SUBJECT: Coastside Design Review Continuation
Cortez Avenue, Miramar
APN 048-032-070; County File No. PLN 2018-00397

At its meeting of May 9, 2019, the San Mateo County Coastside Design Review Committee (CDRC) considered your design review application to allow construction of a new 1,732 sq. ft., two-story single-family residence, plus a 380 sq. ft. two-car attached garage, located on an existing 4,400 sq. ft. legal non-conforming parcel (legality confirmed via PLN2014-00116), as part of a hearing-level Coastal Development Permit (CDP) and a Non-Conforming Use Permit (UP). The UP is required to allow development on a non-conforming parcel with proposed right and left side setbacks of seven (7) feet each, where ten (10) feet is the minimum allowed for each side. No trees are proposed for removal. The CDRC was unable to make the findings for design review recommendation of approval based on certain design deficiencies. In order to resolve these deficiencies in the project's design, a more thorough review of the "Standards for Design for One-Family and Two-Family Residential Development in the Midcoast" manual is required, with emphasis on Section 6565.20(C)2. Complement Other Struct

ROOF and Roof Deck Plan

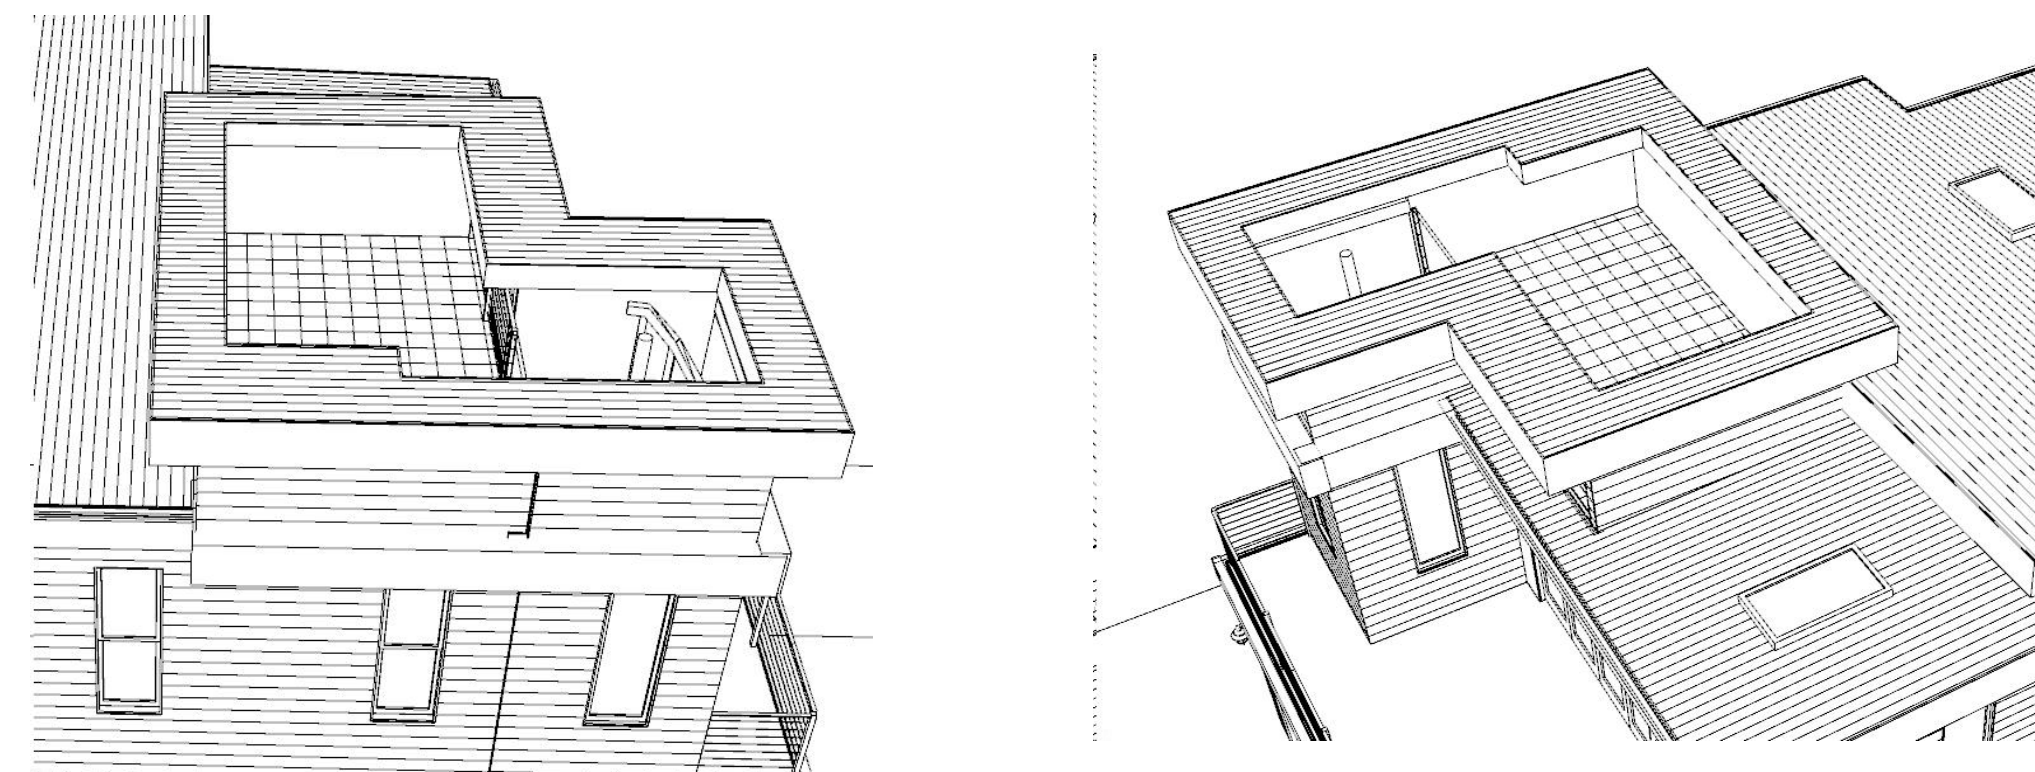
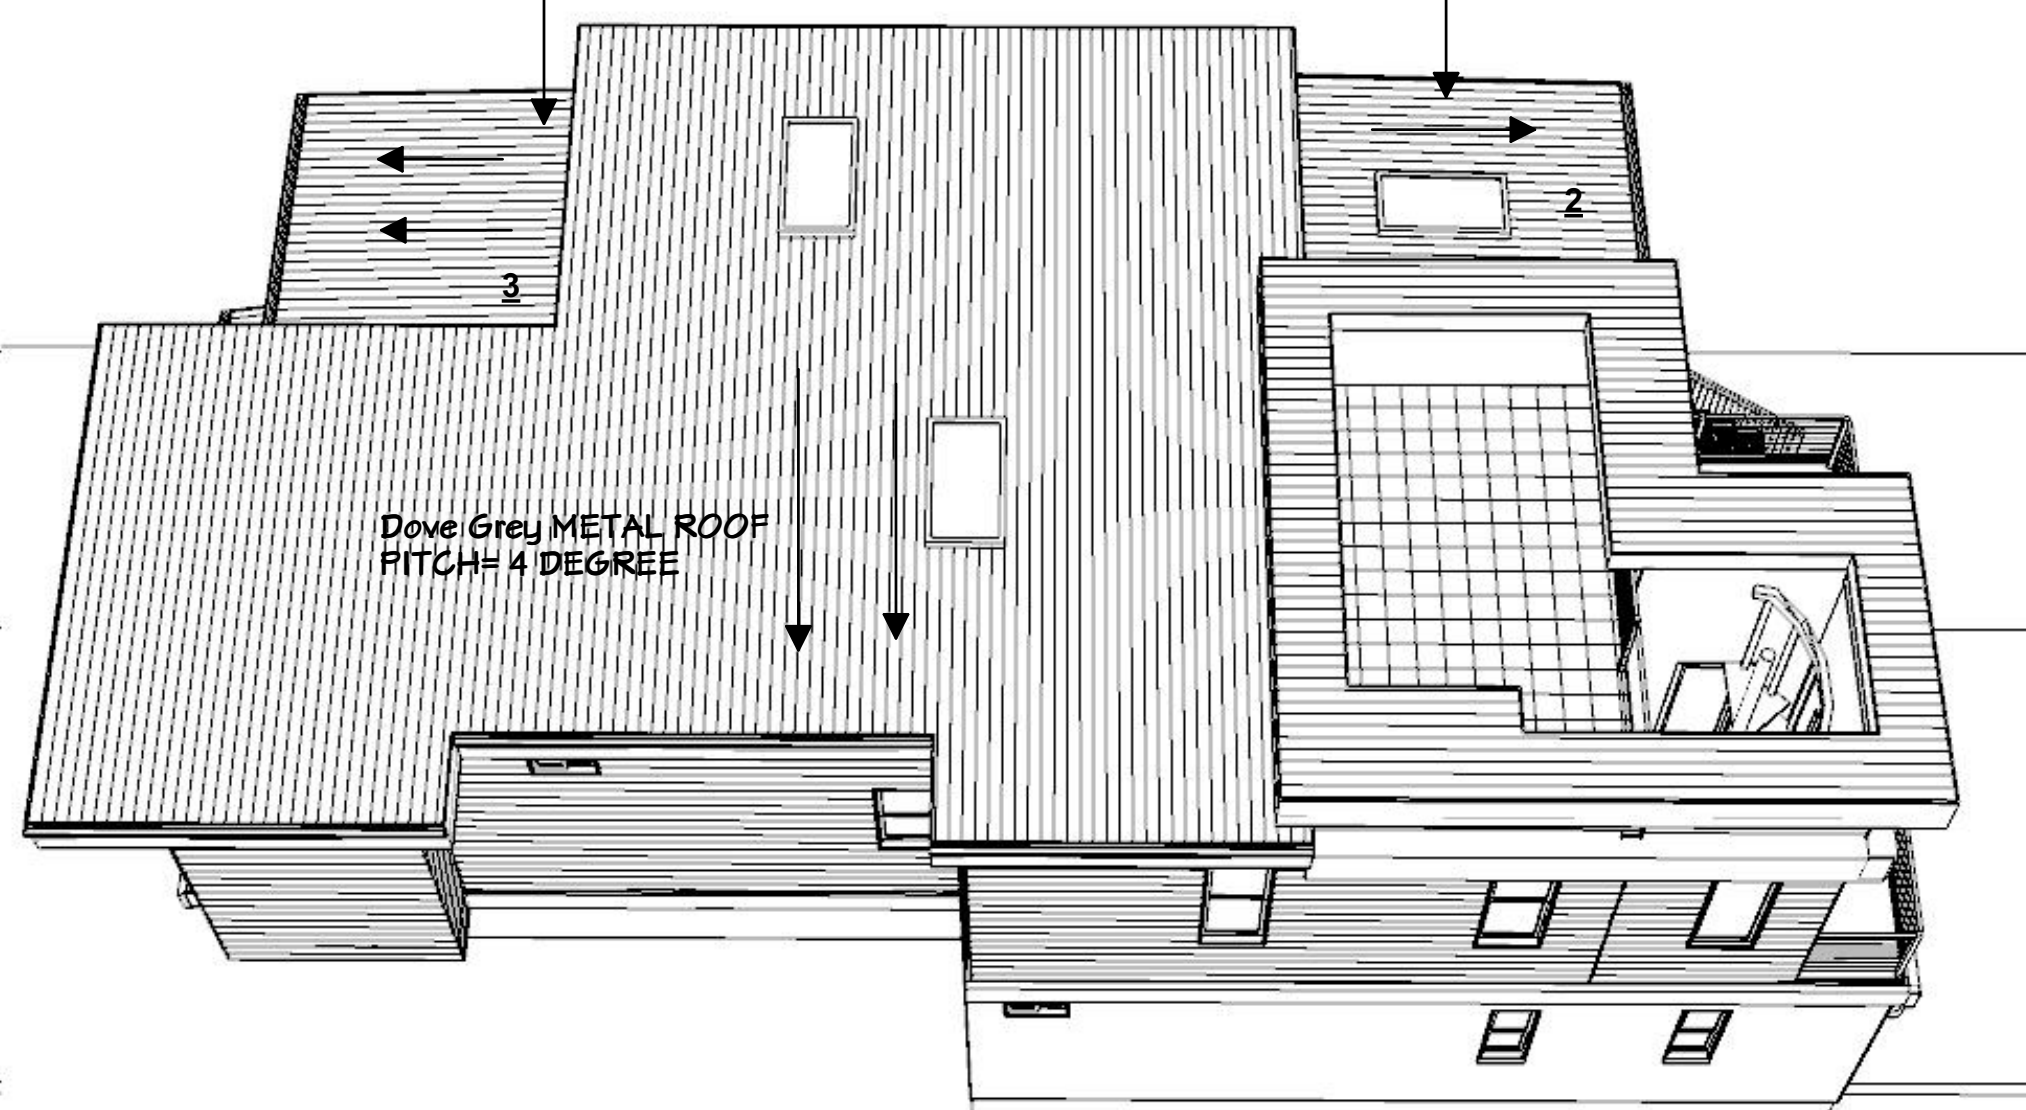
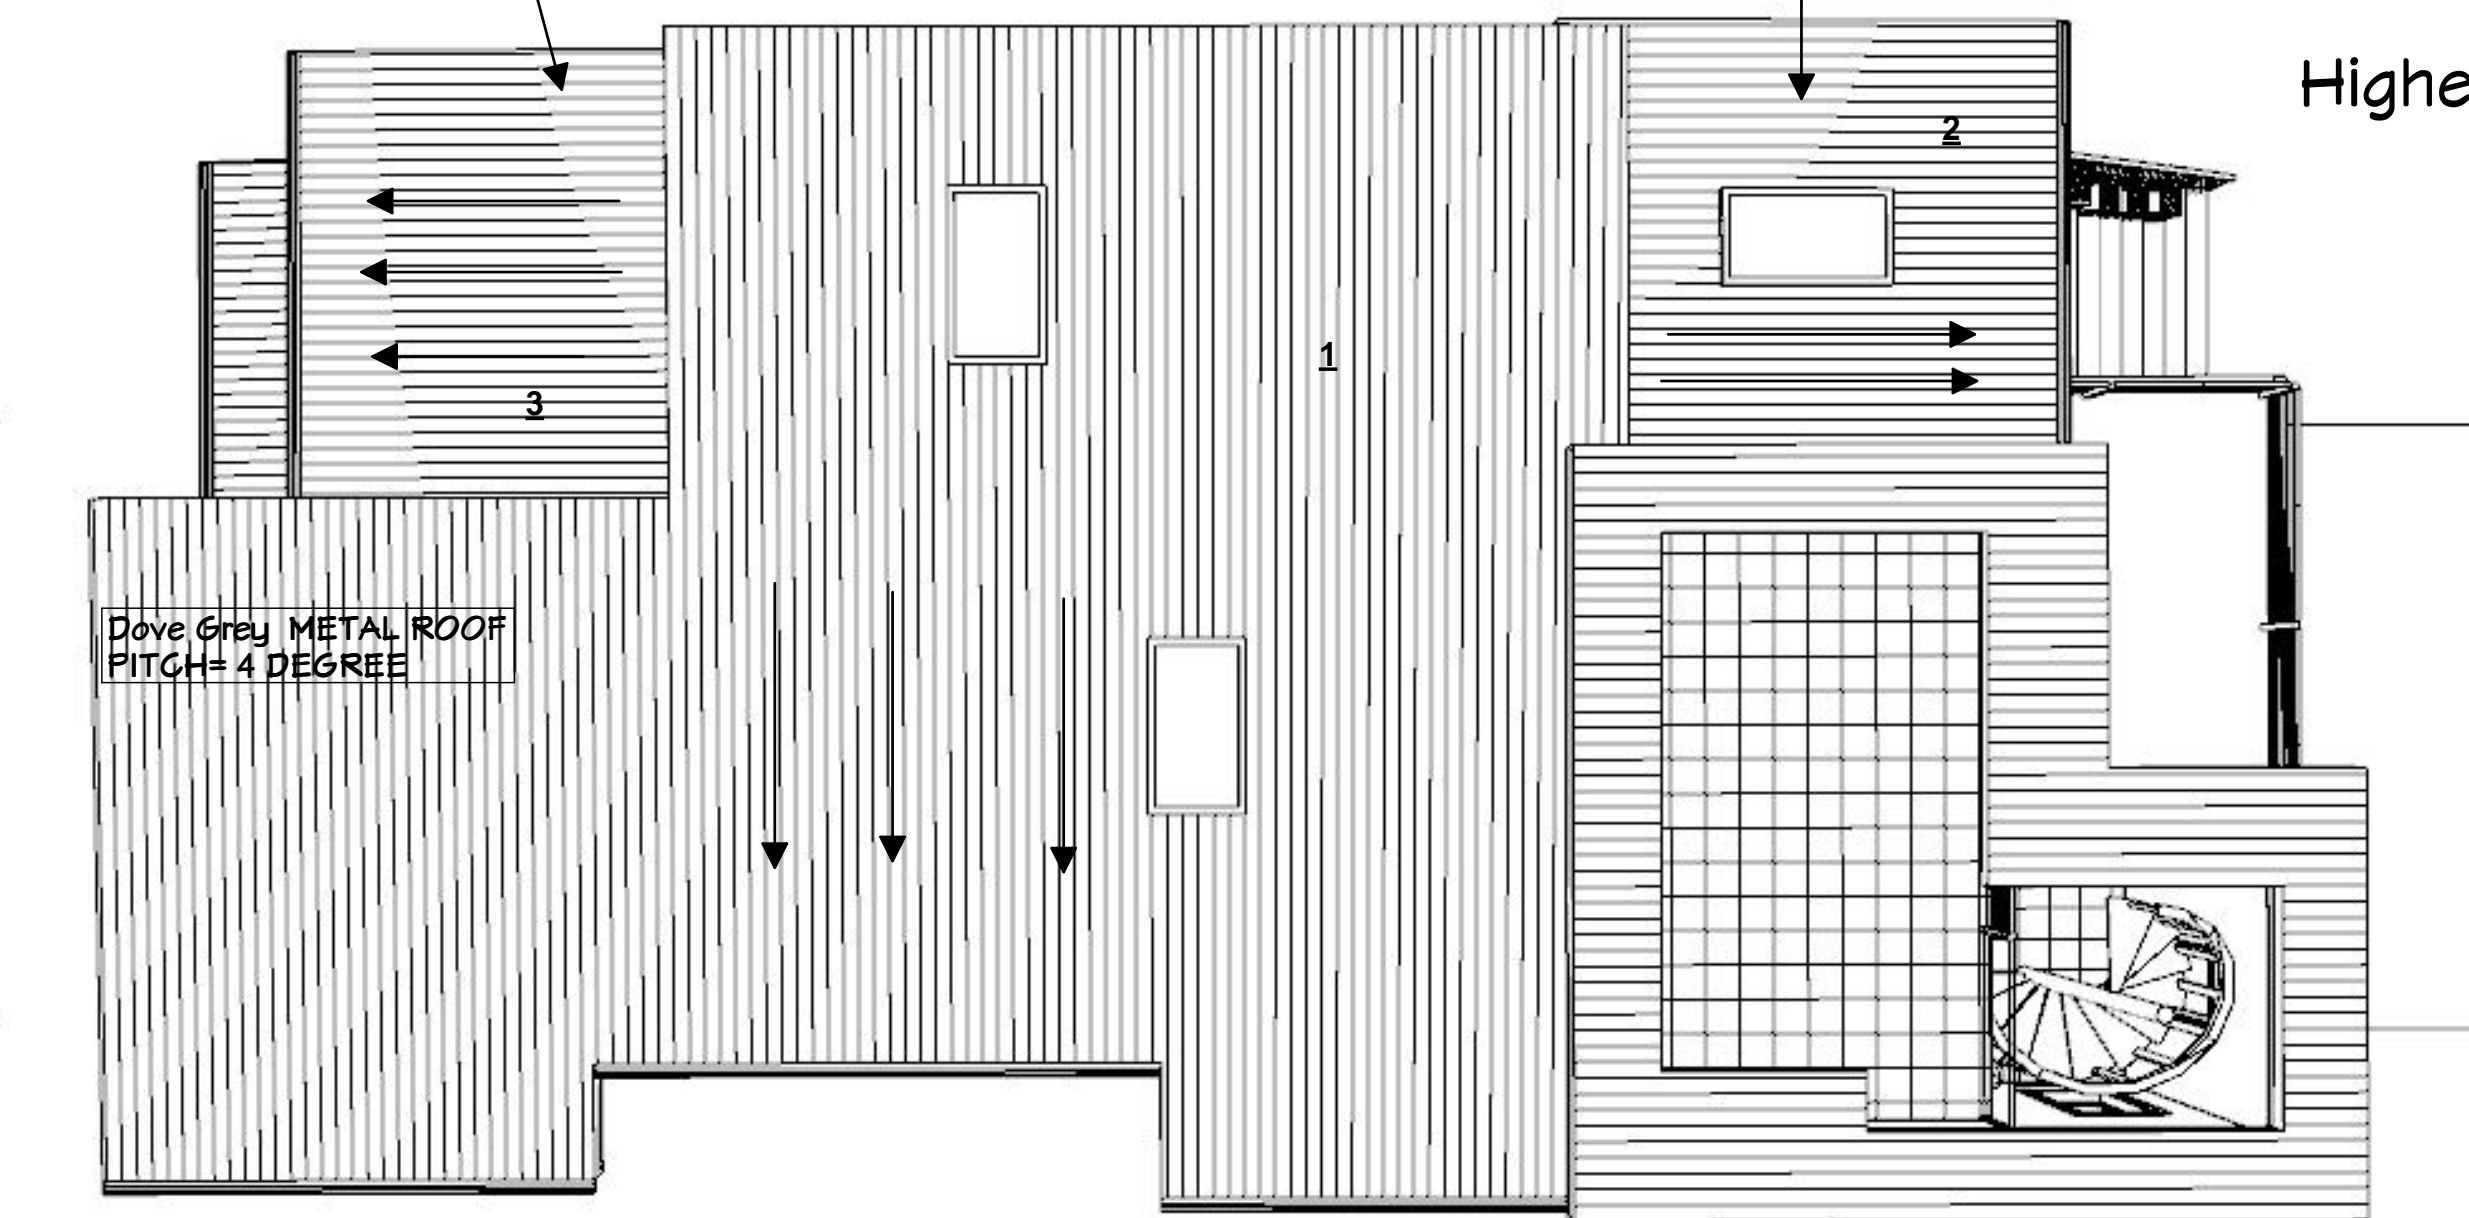
8. Consider eliminating the roof deck to ensure neighbor's privacy.
9. Vertical proportions on the right side of the residence need to be addressed along with the ones on the front facade.

5. Reduce second floor roof height at front of house and reduce visual mass by providing varying eave heights. Consider using a roof form that combines sloping sections in order to reflect other houses in the area.

ROOF FACIA BOARD WIDTH = 18 inches (Box Soffit)

Roof Deck completely hidden , integrated into the roof design

ROOF DECK AREA = 120 Sft now (Rev 3= 194 SQFT) (Rev 2 = 300 SQFT)
